Fair Design Printing LTD.

Shi-140/1, Chandpara, Bashon Sorok, Gazipur Sodor
(23.973972, 90.357666)
05 September 2023

Observations

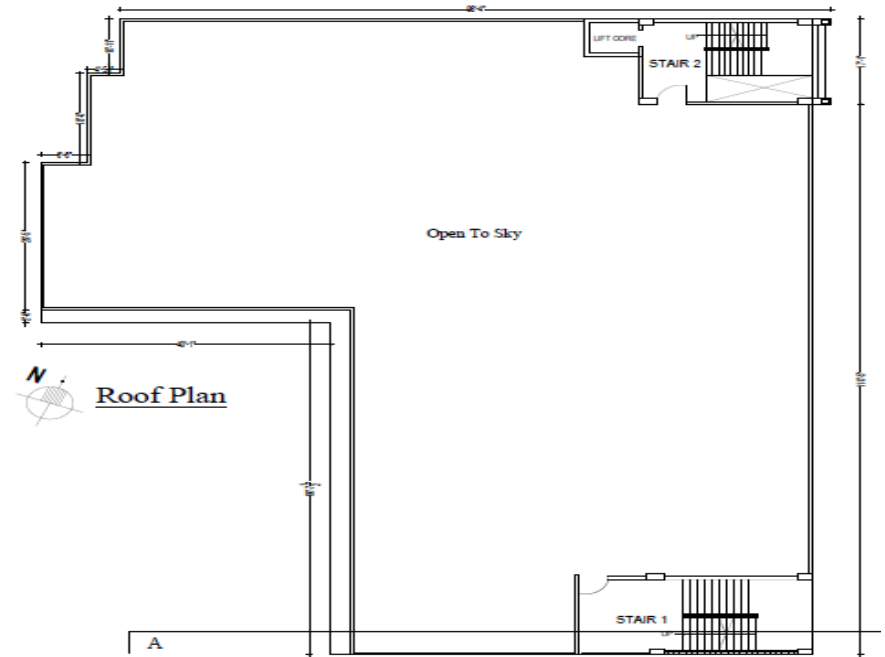
**Structural irregularity check not included in
the design report**

As per building plan, it has an irregular shape which induced torsion into the structure. Also, there is re-entered corner in the building. Building engineer is required to check all type of irregularities & incorporate it in the software-based FEA model & design report.

Non-Engineered lightweight steel roof on staircase

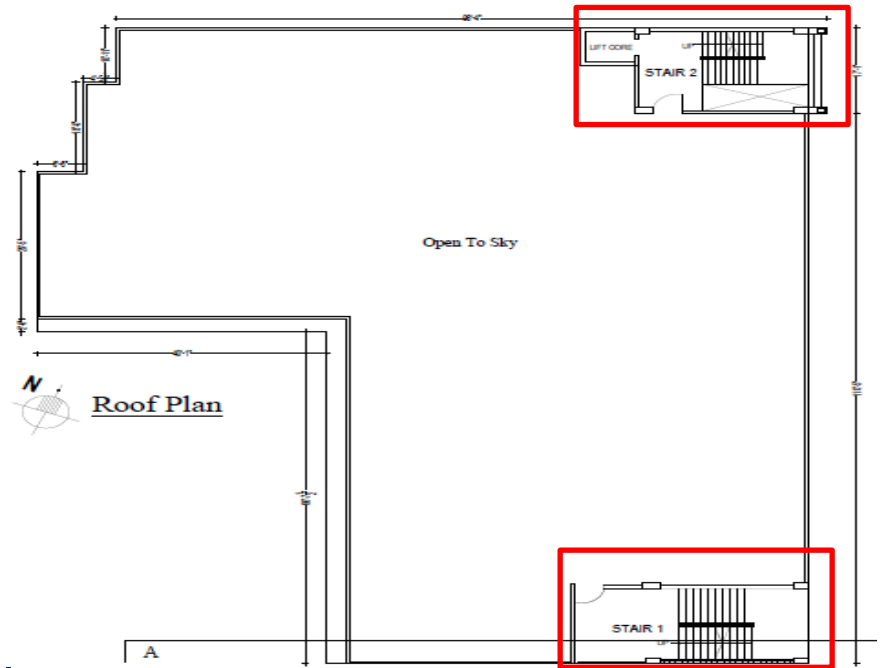
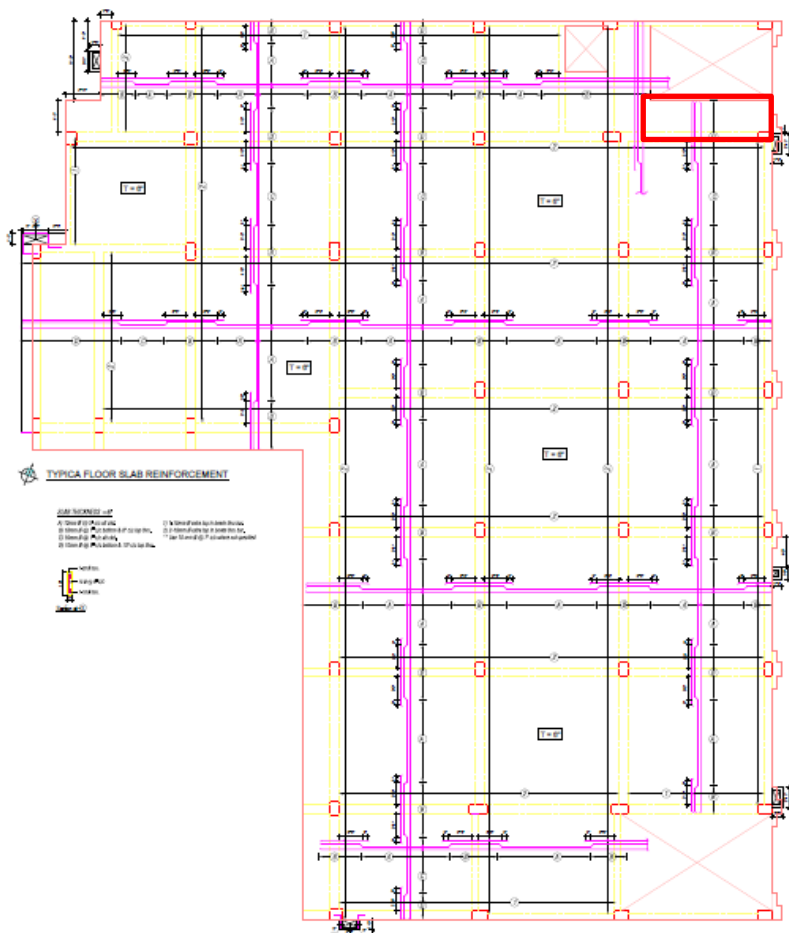
Steel angle member resting on the brick wall

Light weight steel roof resting on the peripheral brick walls. The connection between steel roof & brick wall is apparently non-engineered. The building engineer is required to check the adequacy of stair roof connection against uplift force.

Slab reinforcement layout

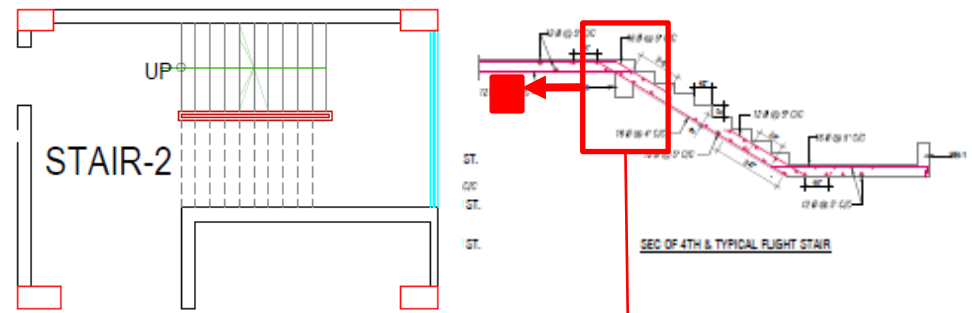
Mismatch found in beam layout and slab reinforcement layout at stair portion; and void portion was not shown in as built drawing. Also marked beam was not in position as per as-built drawing. Building engineer is required to survey the full structure and update the as built drawing and design report accordingly.

Main factory building and utility building structurally connected by slab

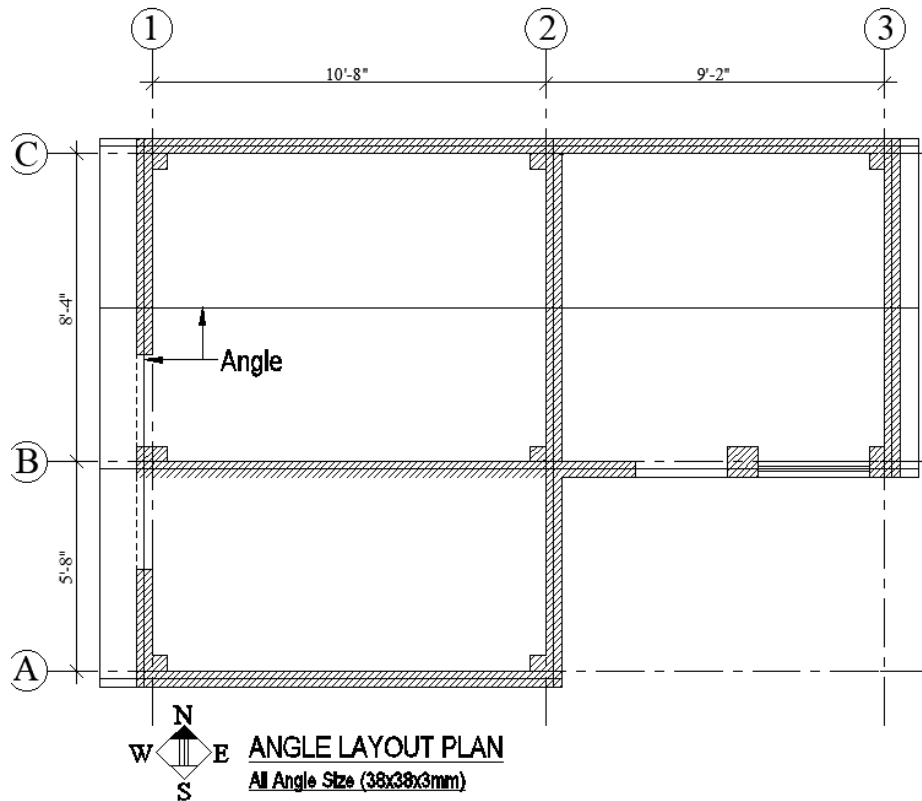
Main Factory Building and Utility building was found structurally connected with the extended RC slab. As per design documents no information was mentioned about this connection. Building engineer is required to check the seismic design provision of the connecting slab.

Rafter layout plan

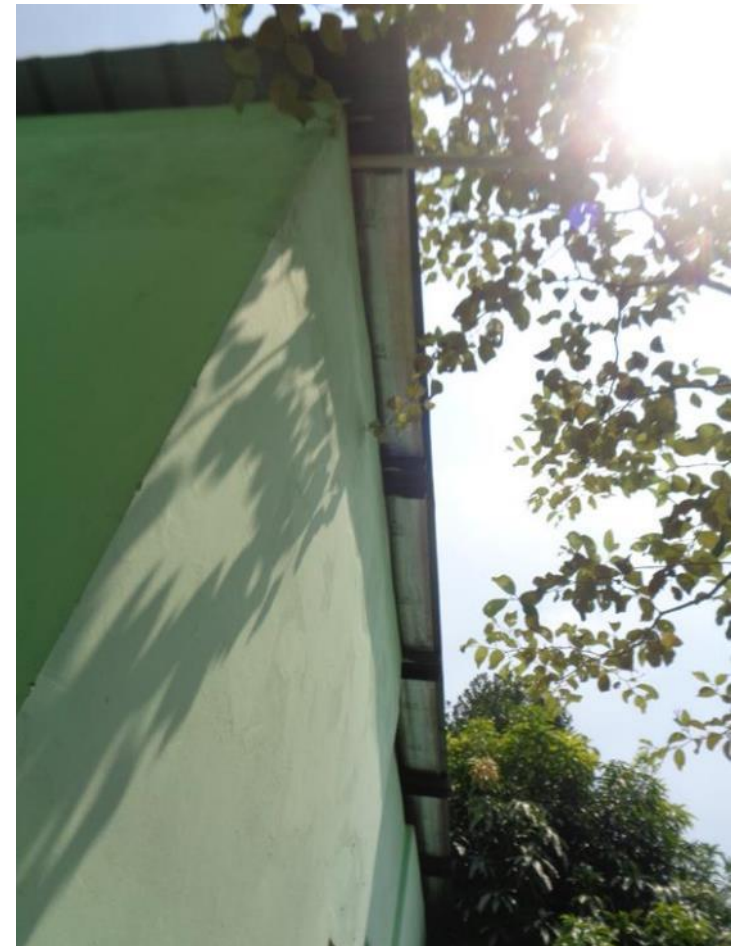
Onsite 5 nos rafter at roof.

During inspection mismatch was found in rafter layout. 5 channel rafter was found in roof where 4 angle rafter was shown in the provided drawing. Also, connection details was found missing. Building engineer is required to survey the full structure and produce accurate as-built drawing.

ETP dry sludge storeroom farming system.

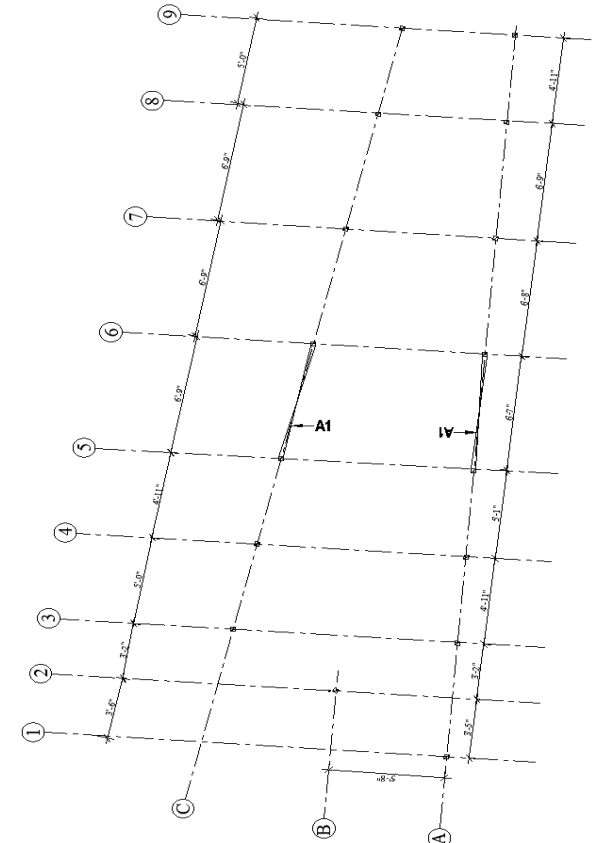
As-built drawing was found for single storied ETP dry sludge storeroom. During inspection, no bracing was found installed as per the bracing layout of as-built drawing. No obvious lateral stability system was observed. Building engineer is required check the lateral stability of the structure and suggest proper remedial actions.
